**Deleted:** Draft GTR from the 6<sup>th</sup> Meeting of the OCE Informal Working Grp Editorial Committee ¶ 171 October/May 2007¶ CLEAN VERSION

The objective of this Global Technical Regulation (“gtr”) is to establish a harmonized regulation which ensures off-cycle emissions from heavy-duty engines and vehicles are appropriately controlled over a broad range of engine and ambient operating conditions encountered during normal in-use vehicle operation. The gtr is designed to be applicable to engines certified or type approved under the test procedures of the World-Harmonized Heavy-duty Certification (WHDC) gtr.

**Figure 1 : Illustration of Ambient Altitude and Temperature Conditions** ~~Figure to be revised by EPA~~

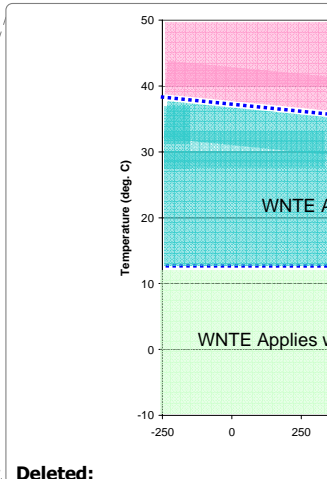
**Editorial comment: EMA and OICA would like the current altitude value to be expressed in an equivalent barometric pressure value and will look at data and bring forward a proposal to the group for consideration.**

Figure 2: Example WNT<sub>E</sub> Control Area

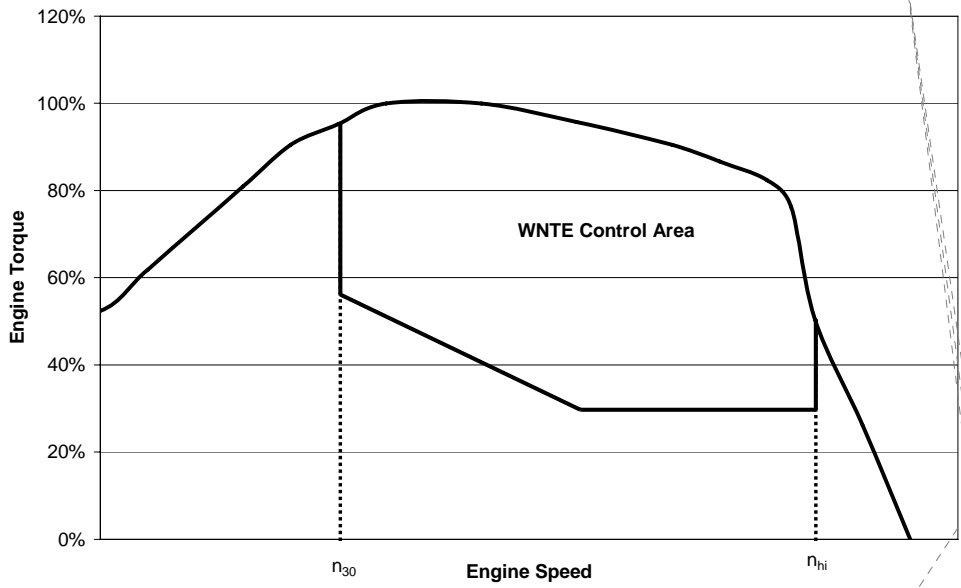
Editorial Comment: Will update diagrams to correspond with final control area established in gtr and will add example figures

Figure 5: WNT test cycle grid [new figure to be provided by EC]

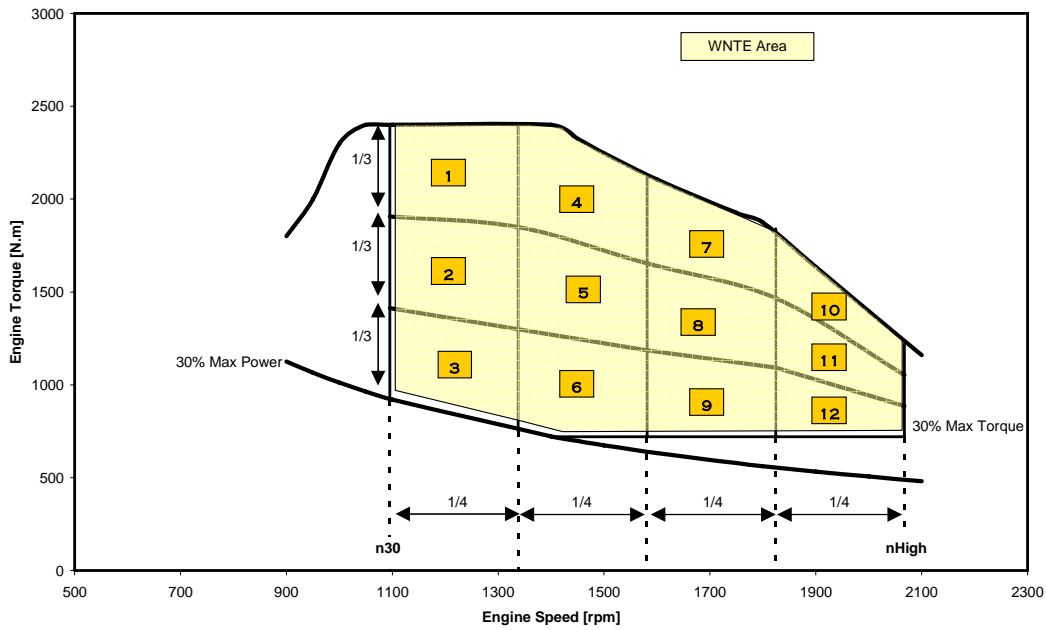
~~An example of the grid applied to a specific engine is shown in Figure 5. [examples of both the 9 and 12 grid figures will be provided by the EC]~~
